LETTER SUBMITTING MISSING INFORMATION FROM OIL WATER SEPARATOR  
ASSESSMENT REPORT FOR BUILDING 200 MAIN BASE NTC ORLANDO FL  
1/9/1997  
ABB ENVIRONMENTAL

Subject: Oil/Water Separator Assessment Report  
Building 200, Main Base  
Naval Training Center, Orlando, Florida  
CTO 107, Contract No.: N62467-89-D-0317

**FIGURE 1  
SITE PLAN**

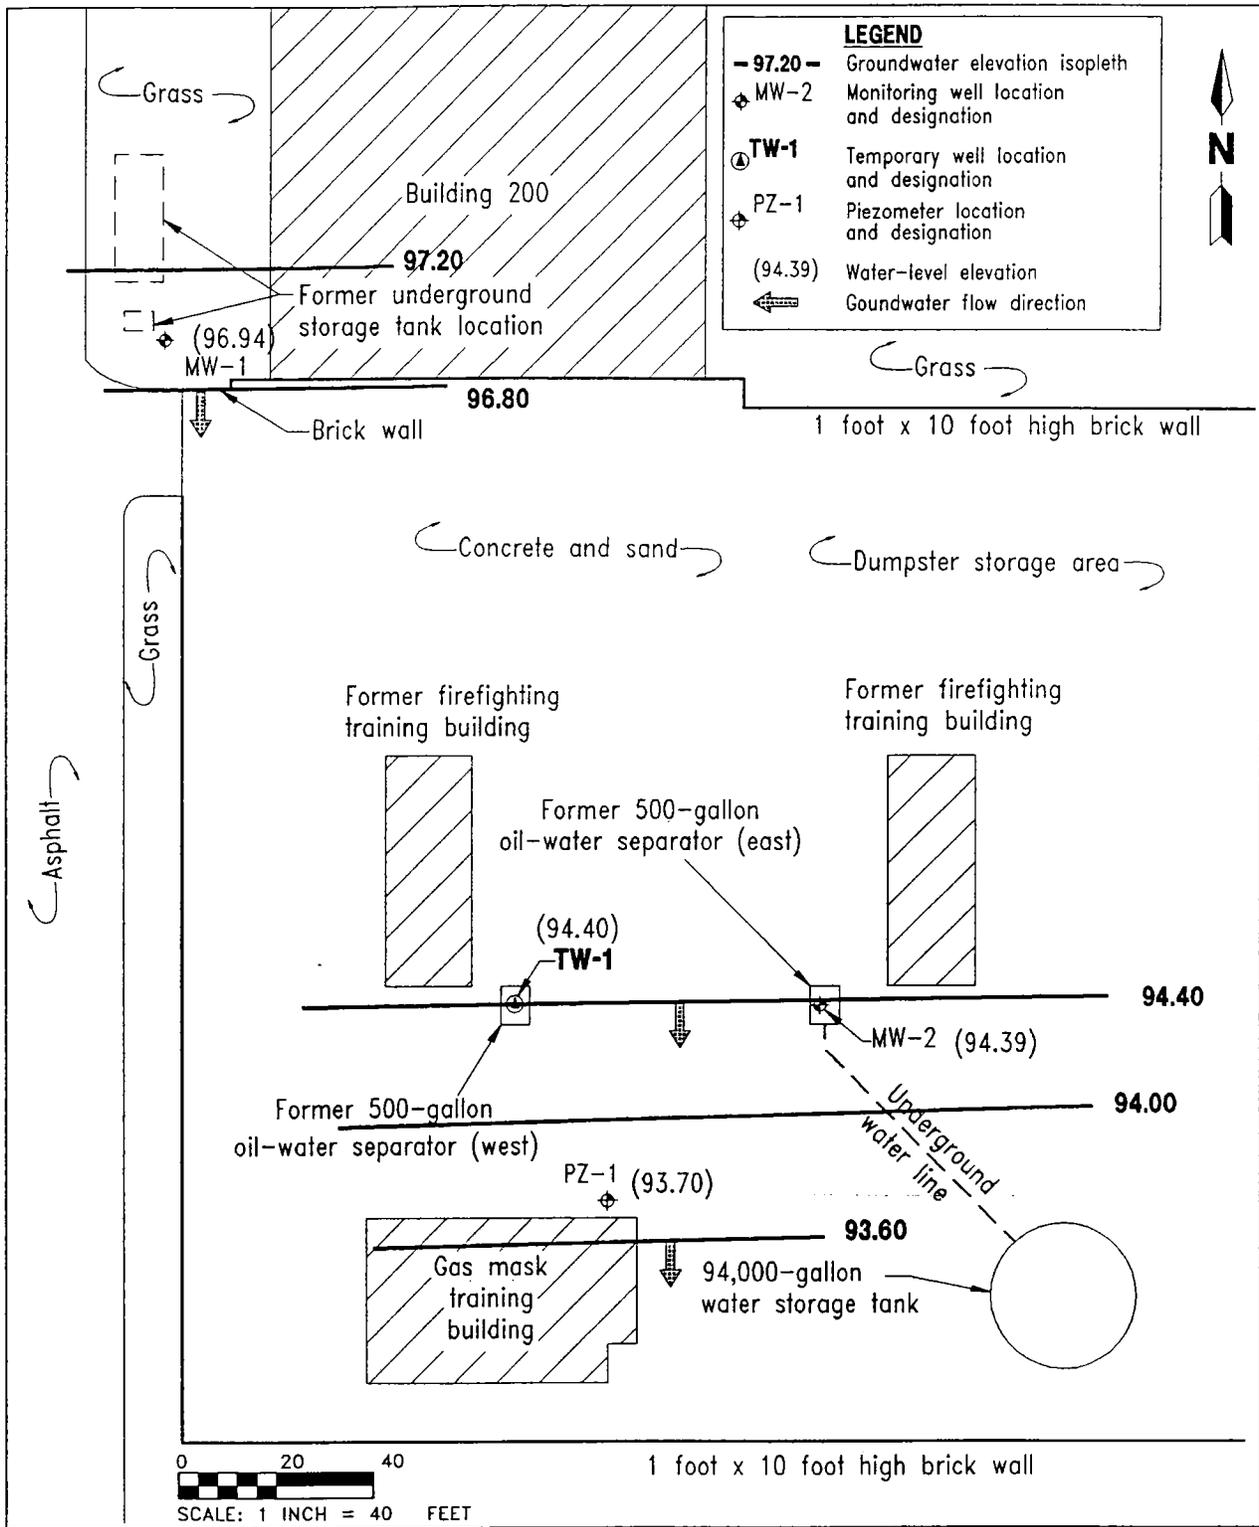
I have completed the technical review of the above  
referenced document dated November 1996 (received November 12,  
1996). I agree with the conclusions and recommendations that a  
contamination assessment is needed for the eastern Oil/Water  
Separator. However, the information for determining groundwater  
flow was not in this closure assessment report. I question the  
groundwater flow direction as southerly due to other  
investigations performed in this area which indicate groundwater  
flow to the northeast or east-northeast. This needs to be  
adequately documented in the Contamination Assessment Report.

As stated in your letter dated December 16, 1996, the information for determining groundwater flow at the above-referenced site was not included in the Oil/Water Separator Assessment Report. The attached table and figure summarize the information used to determine groundwater flow during the assessment activities.
